DEVELOPMENT DETERMINATION PANEL MEETING

WEDNESDAY 11 MAY 2022

ITEM 3.1	DA2021/2149 - 2 TOURMALINE STREET NARRABEEN - CONSTRUCTION OF DWELLING HOUSE
REPORTING MANAGER	Lashta Haidari
TRIM FILE REF	2022/265071
ATTACHMENTS	1 ↓ Assessment Report 2 ↓ Site Plan and Elevations

DEVELOPMENT APPLICATION ASSESSMENT REPORT

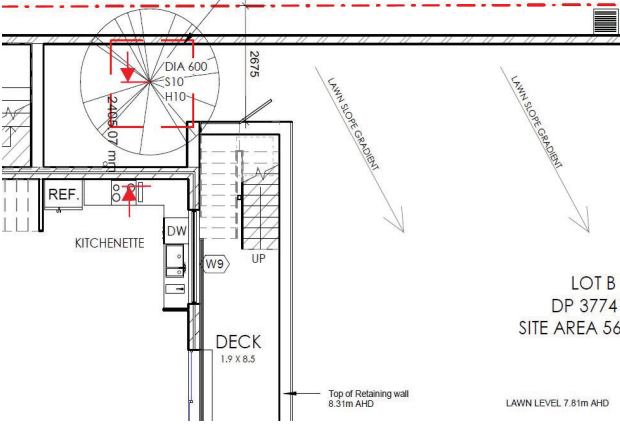
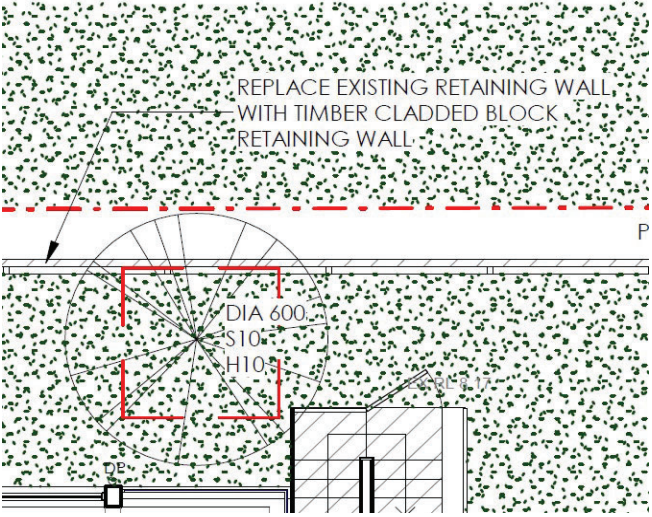
Internal Referral Body	Comments
	<p>A) Required offset from the tree</p> <p>3.2.7 It is noted the root mapping was conducted where the wall of the dwelling is proposed approximately 700mm south of the existing timber retaining wall south of the tree. It will be recommended this existing wall is retained, and the new wall is located at the point of root mapping trench to avoid further cutting back of roots towards the base of the existing timber wall.</p> <p>Based on the requirements of the Report, the new wall can be no closer than 700mm off existing planter. Based on the Survey Plan, this represents a distance of 2.4m off the tree (red arrows on the extract from the Survey plan below).</p>  <p>When this distance is overlain onto the design plans, it is evident that the wall of the Kitchenette is within the offset and will need to be further offset from the tree, as will proposed stairs (Note red arrows on plan extract below). These amendments are alluded to in the Report:</p> <p>3.2.8 Further to this, it will be a recommendation that portions of the deck stairwell and stairs access to the west of the tree are amended to provide sufficient soil area in the tree's root zone to avoid additional loss of roots. This would reduce the TPZ encroachments via construction to a similar level to the existing. This recommendation is particularly important in light of the pruning required of the tree to accommodate the building and roof, and steps to reduce the loss of anchorage (via root removal) on the pruned side of the tree.</p>

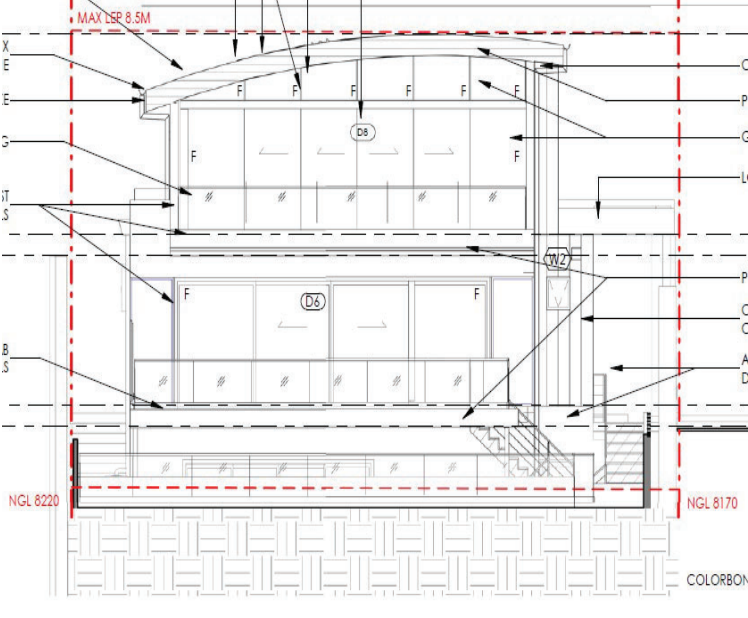
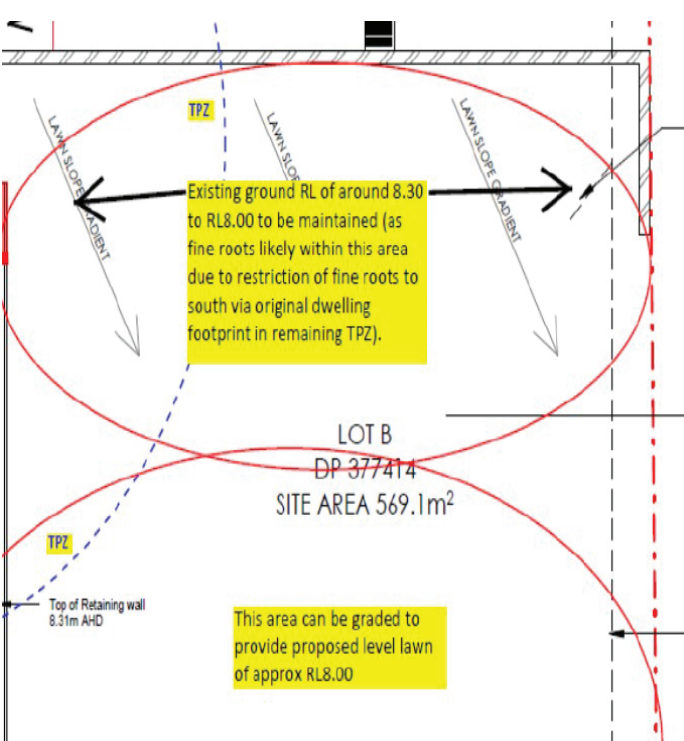
Internal Referral Body	Comments
	 <p>B) Impacts of northern retaining wall</p> <p>3.2.9 Construction of a new wall to replace the existing on the north side of the tree will require to adopt sensitive construction measures to avoid root loss and preventing soil moisture available from the street and road reserve from entering the tree's root zone. This wall could have a continuous strip footing or a depth that interferes with water movement within a minimum distance of 8.7m as demonstrated at Appendix F.</p> <p>It is evident from the plans that the wall referred to along the northern boundary is a retaining wall. Details of the wall are provided on the plans. Construction of the wall as indicated will completely sever all roots within the Tree Protection Zone and Structural Root Zone along tree's northern side. The proposed wall location and construction detail will not enable retention of the tree and is contrary to the Arborist's Report.</p>

59. **Trafficable garage roof prohibited**

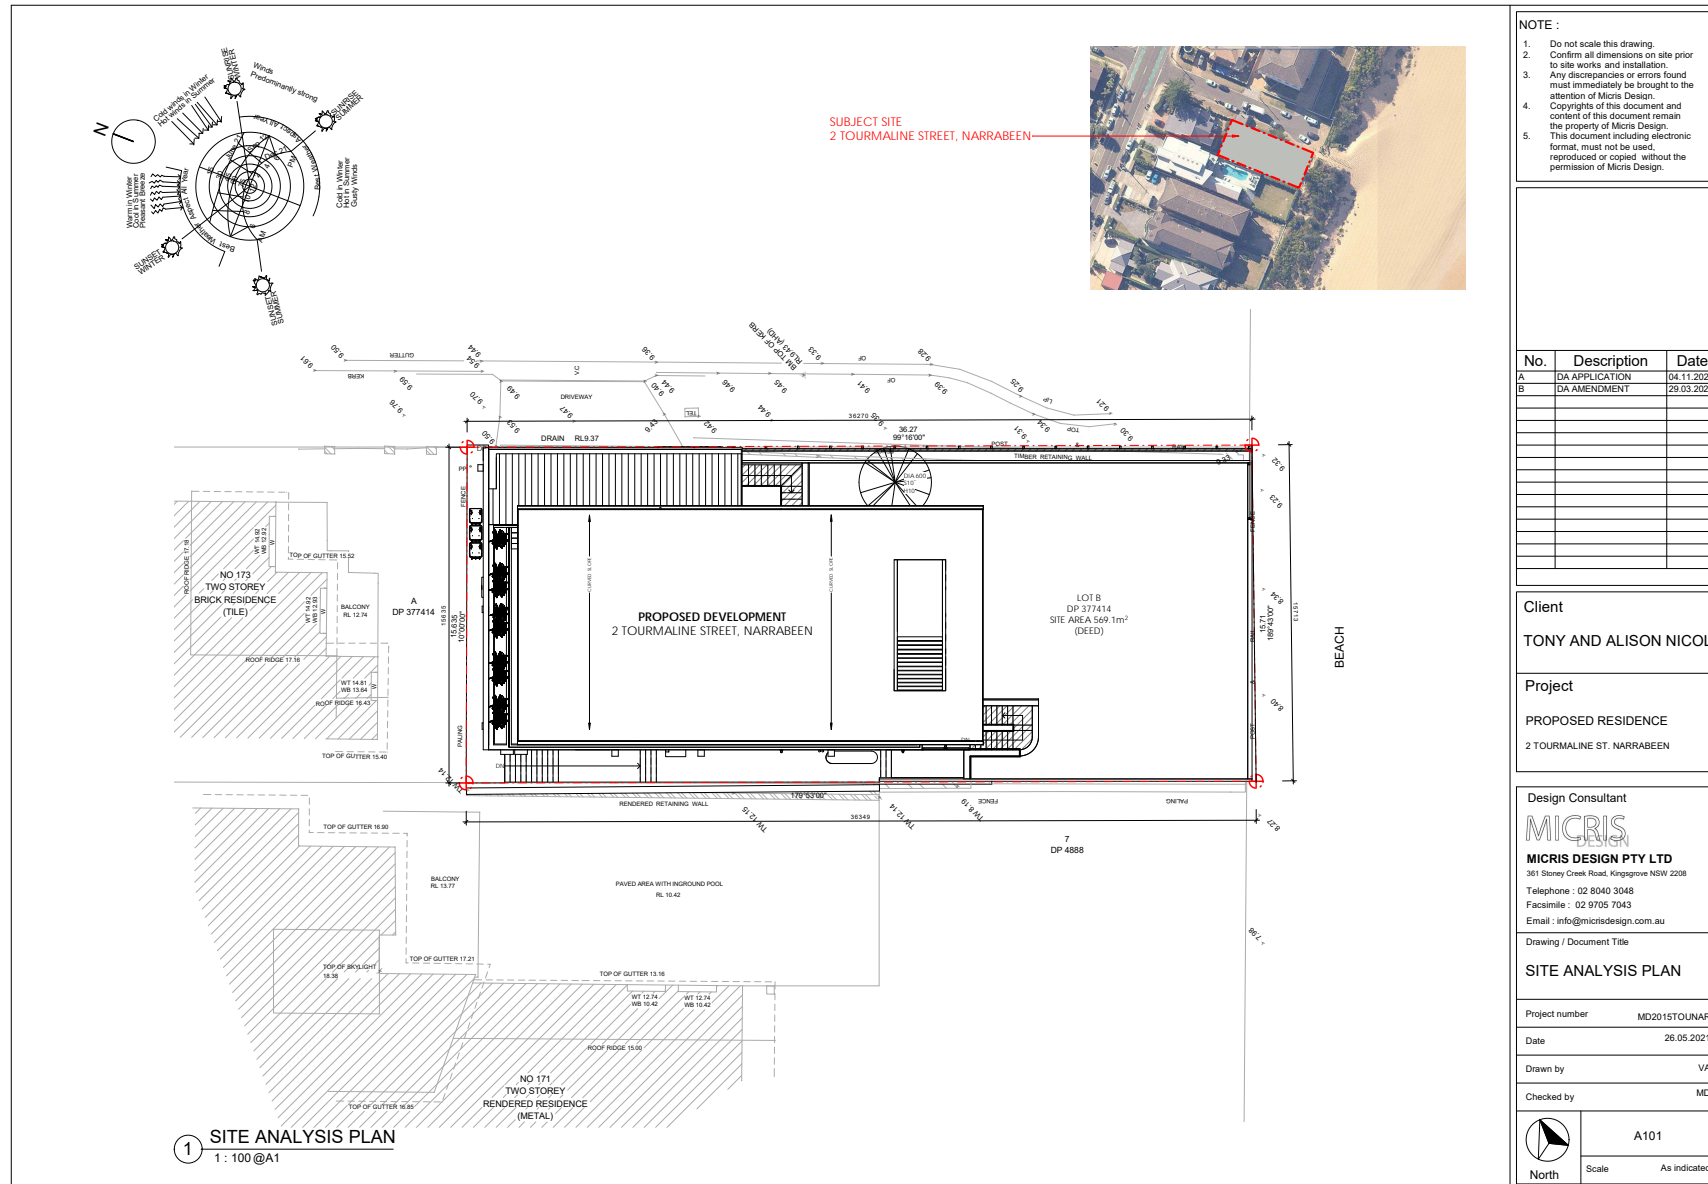
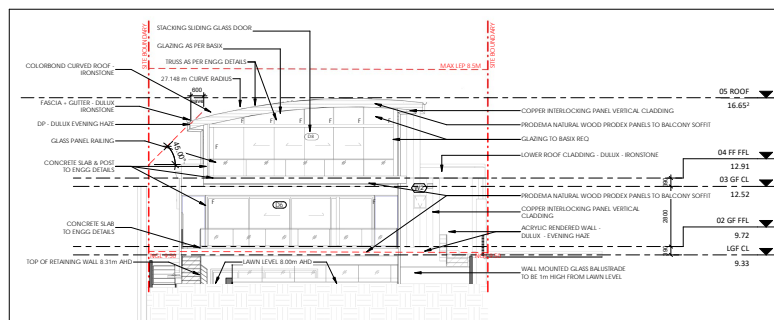
The trafficable use of the roof over the garage and entry porch is prohibited.

Image 1 - Height non-compliance

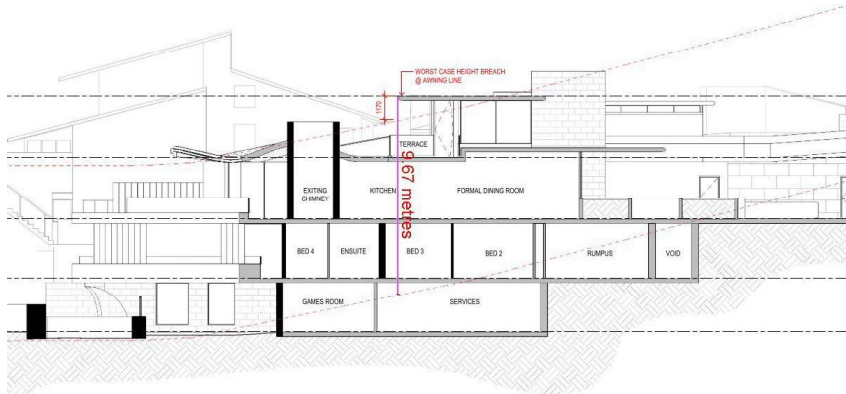
Development standard:	Height of buildings
Requirement:	8.5m
Proposed:	9.67m
Percentage variation to requirement:	13.7%
